SURVEY PLAT FOR
PROPERTY TRANSFER

PART NW AND SW QTR. SEC. 18, T-20
R-18, WASHINGTON TOWNSHIP
RICHLAND COUNTY, OHIO

Lot Split Application

HEALTH DEPT. MAP

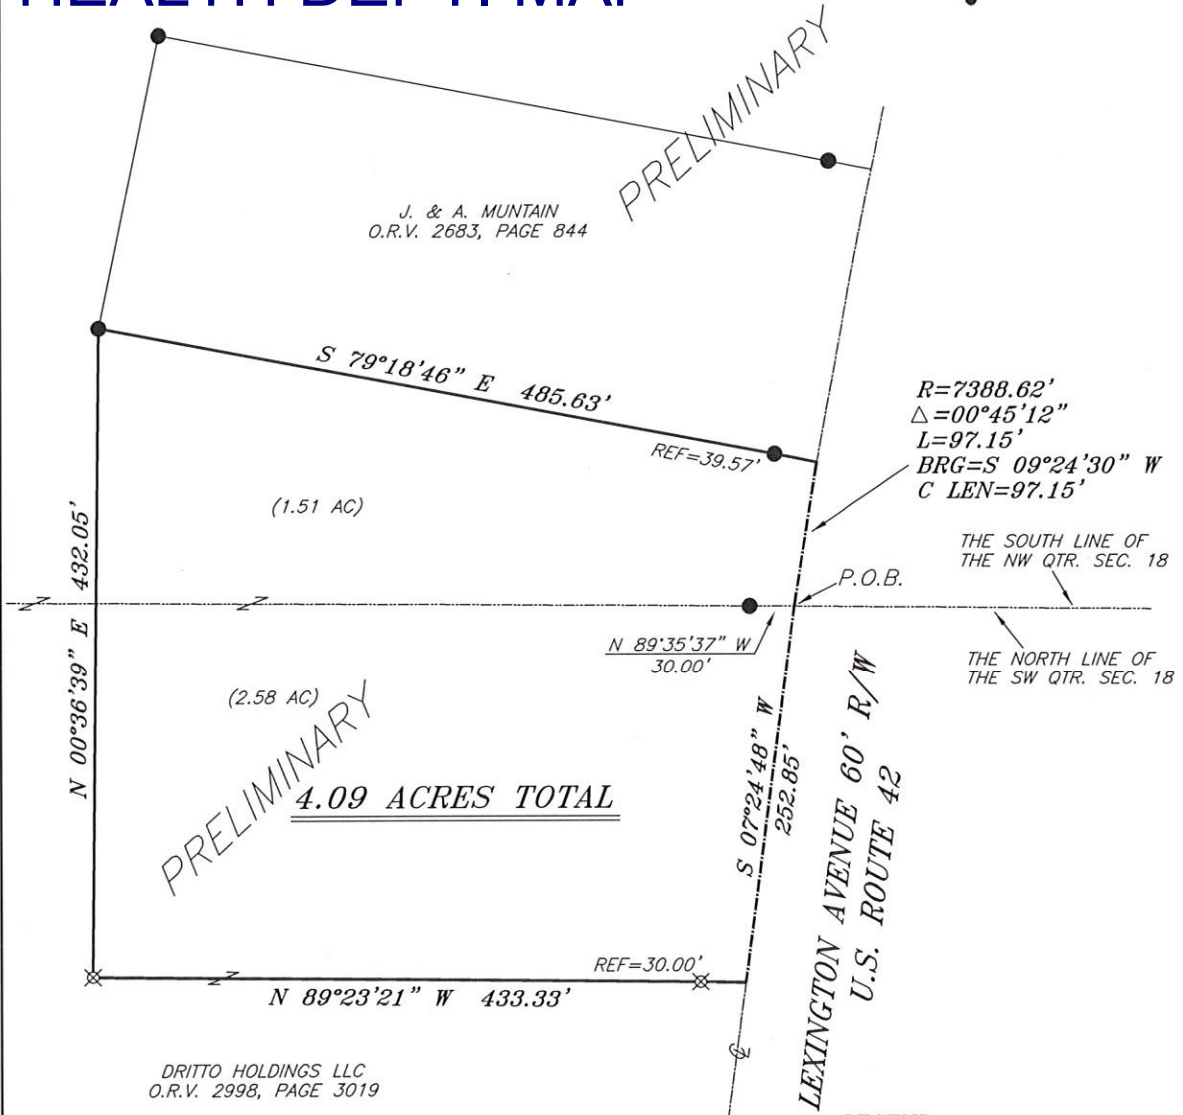
Will approve once stamped survey is provided, so long as it does not differ from proposed drawing to the point that it effects the layout., Must contain language from preliminary survey description. This site has been approved for use that does not require a onsite sewage treatment system.
